**CERTIFICATE OF APPROPRIATENESS**

**RE: Application Number 21-7527; 1441 Brooklyn Street (AKA Kaul Glove Building), Corktown Historic District**

- Revision to previously approved proposal (#20-6777) for general rehabilitation including window and door replacement and relocation of awning.

NOTE: This information being submitted is for revisions related to the windows for the originally approved COA. The proposed change is from the Time-Life storefront window system without operable windows to the industrial sash style windows with an operable section as shown on the updated elevations and window details provided by Seal-Craft windows.

Sheet Number:  
**A5.10**

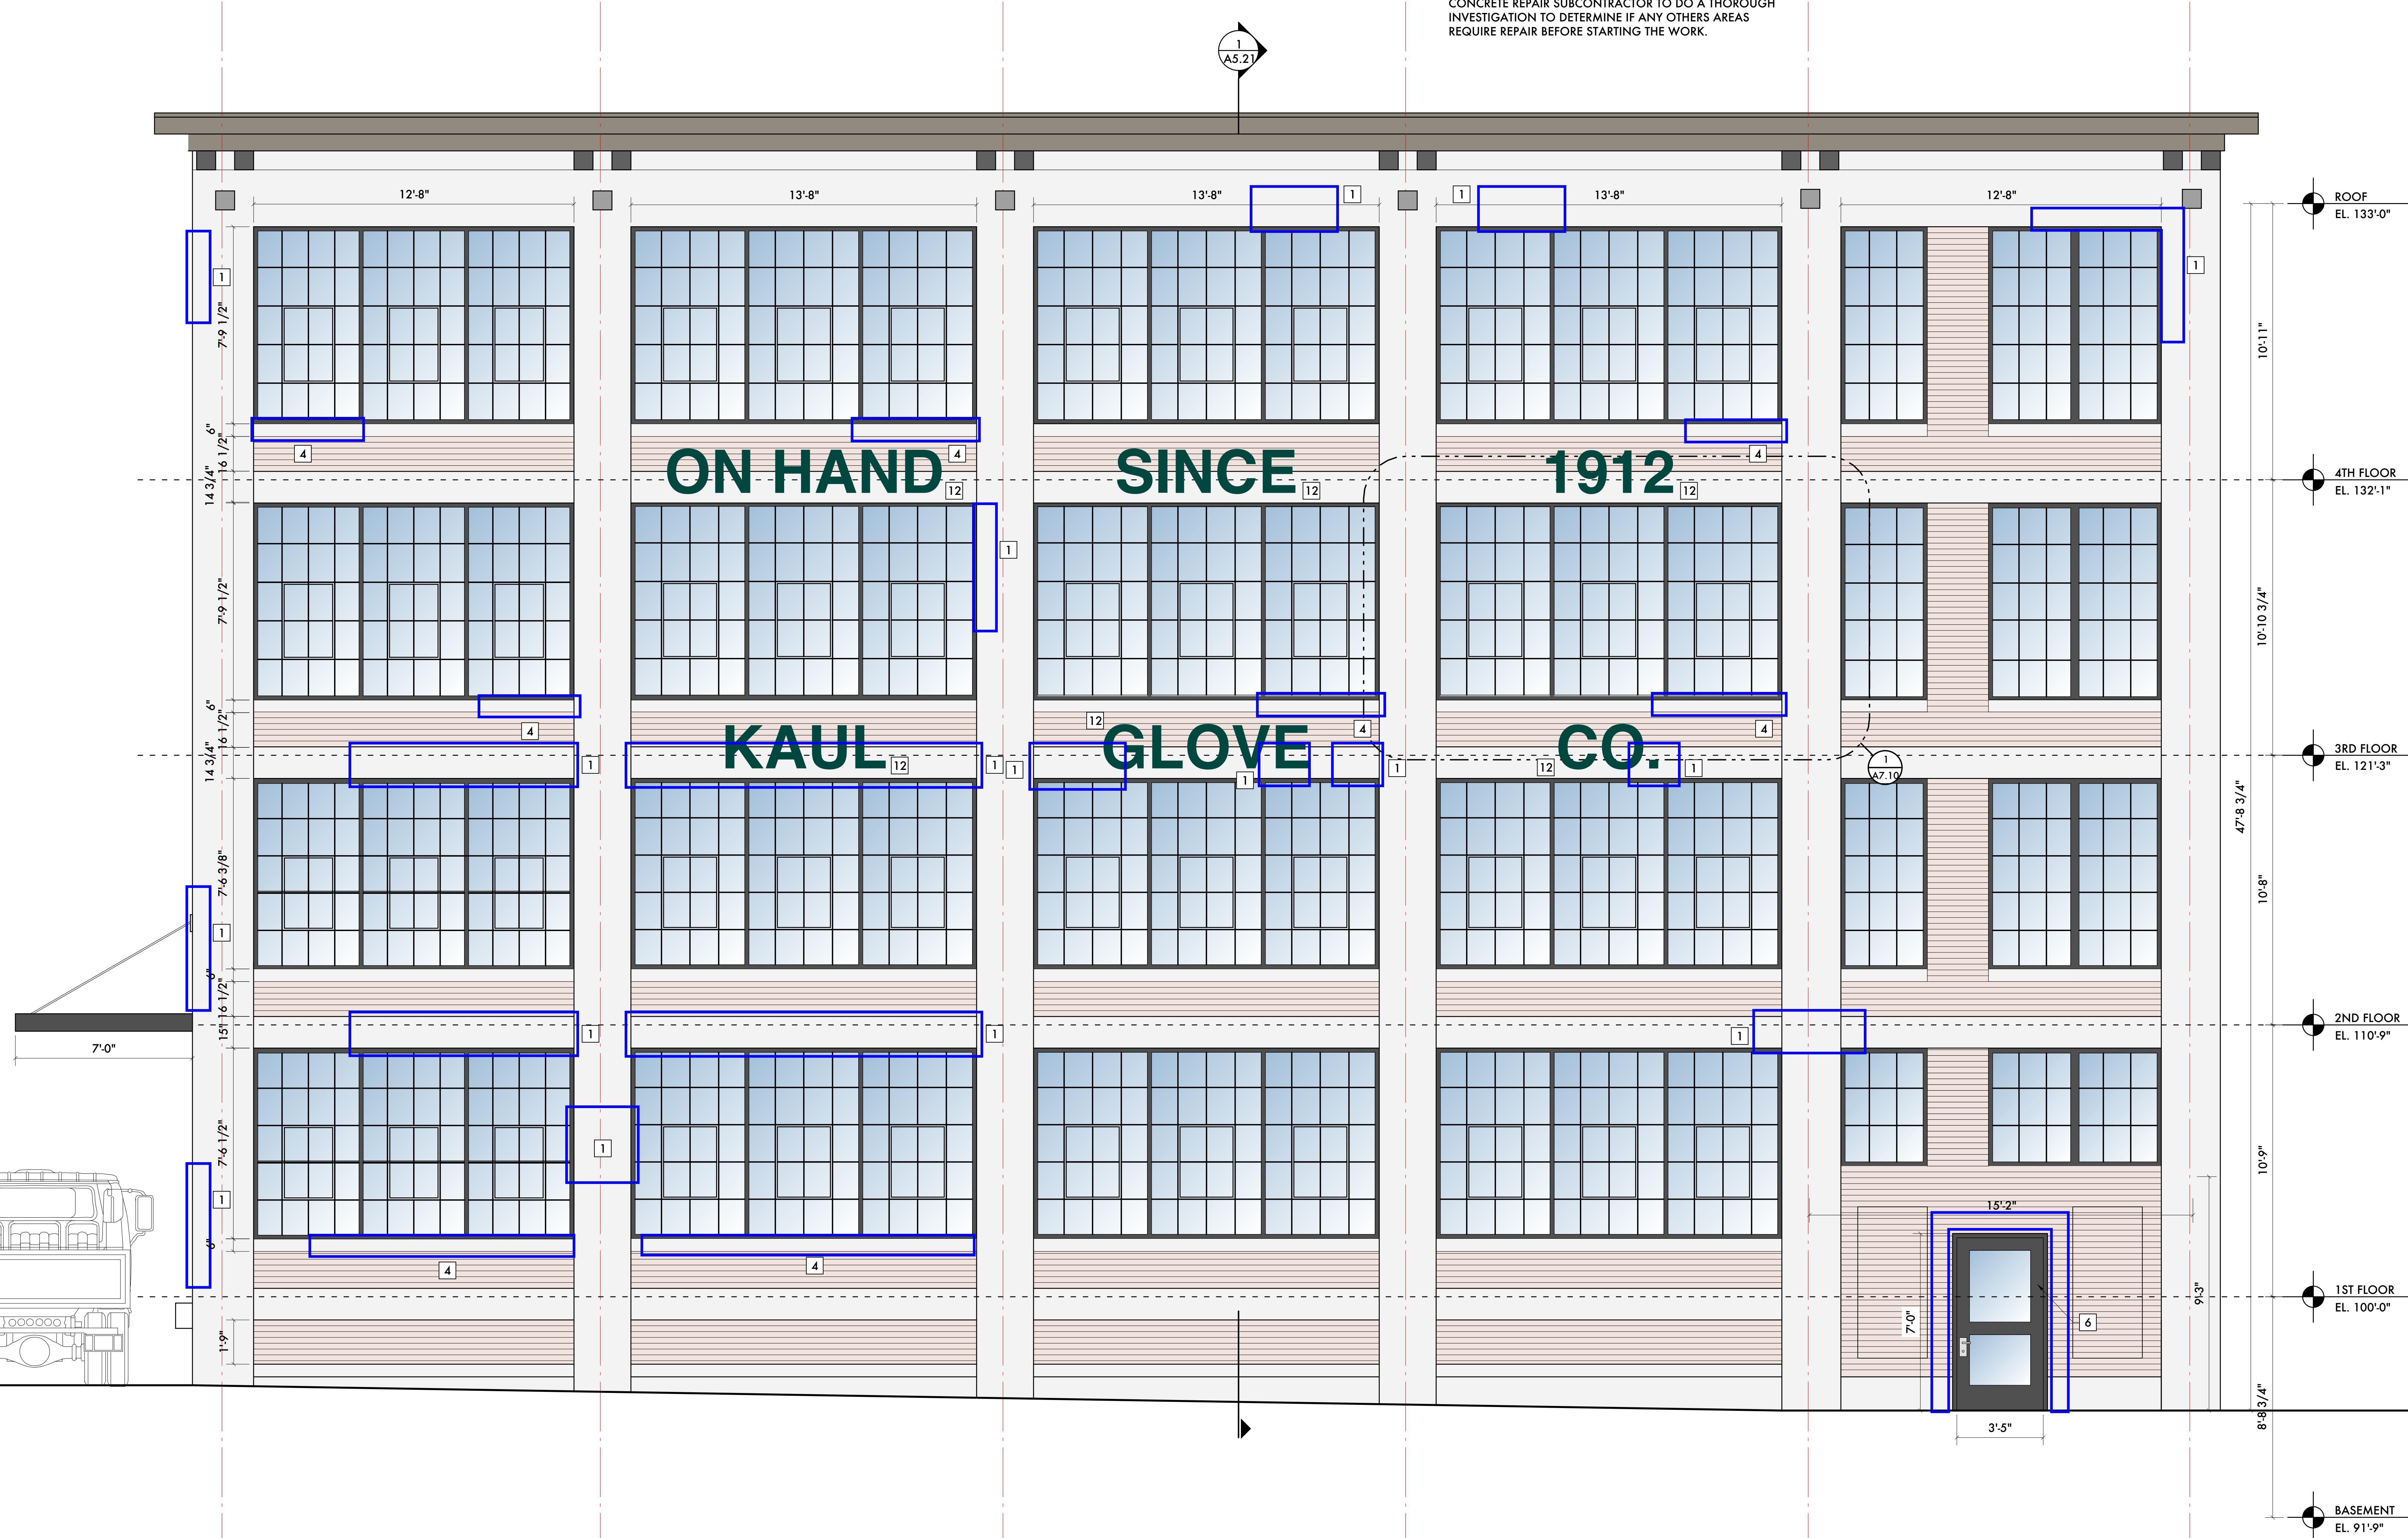
# This elevation WAS approved by the Commission - all floor plans need revision to reflect this elevation composition.
